Oakdale Industrial Estate Site 1A

Section 75W Modification to MP08_0066

April 2013

FIGURE 2 – APPROVED DEVELOPMENT AND PROPOSED INTERNAL MODIFICATIONS

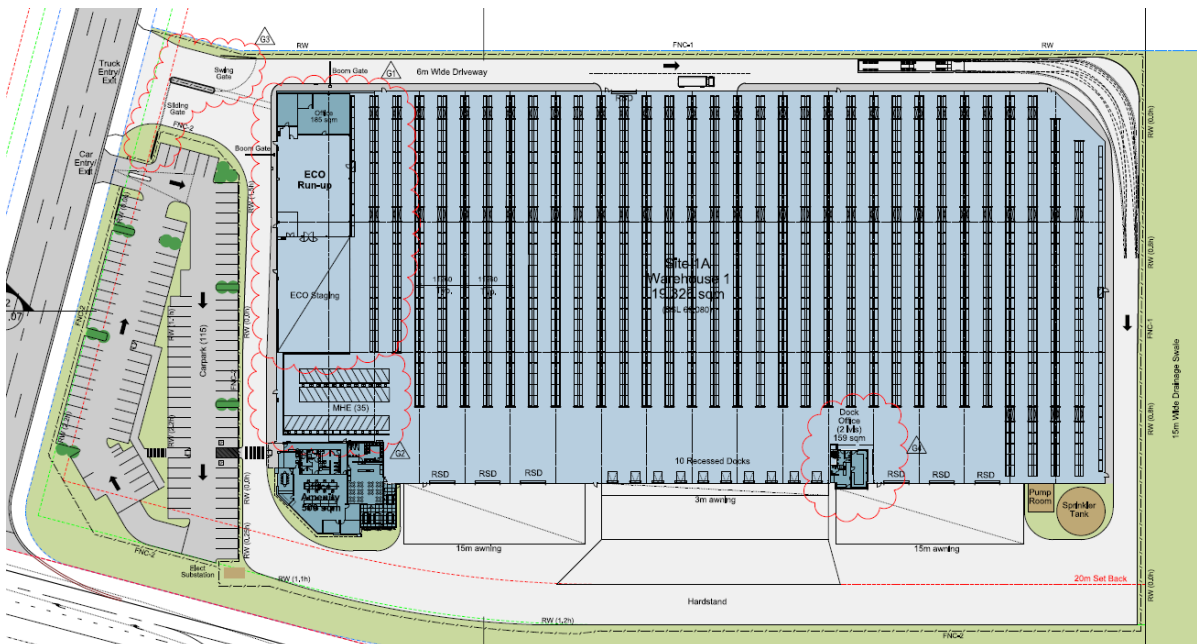
- Relocation of the approved sliding gate at the truck entry access point so that it is further to the south adjacent to Estate Road 01.
- Relocation of the approved swinging gate at the truck entry access point so that it is further to the south adjacent to Estate Road 01.
- Minor modification to the façade treatment along the eastern elevation to reflect the proposed modifications to the internal layout.

- Allocation of the following warehouse use areas:
 - An 'eco-run up' workshop area including a spray booth where goods including copies and cameras will be serviced.
 - An 'eco staging' workshop area including a chain-link fence where pallets are delivered prior to going through to the eco run up.
 - An MHE area including storage bays where the forklifts will be stored and charged.
- Inclusion of an additional office area in the south west corner of the building with:
 - A main office room.
 - A meeting room.
 - Break out area and amenities.

A comparison of the previously approved development, current approved scheme and the proposed modifications are shown in Figure 2.
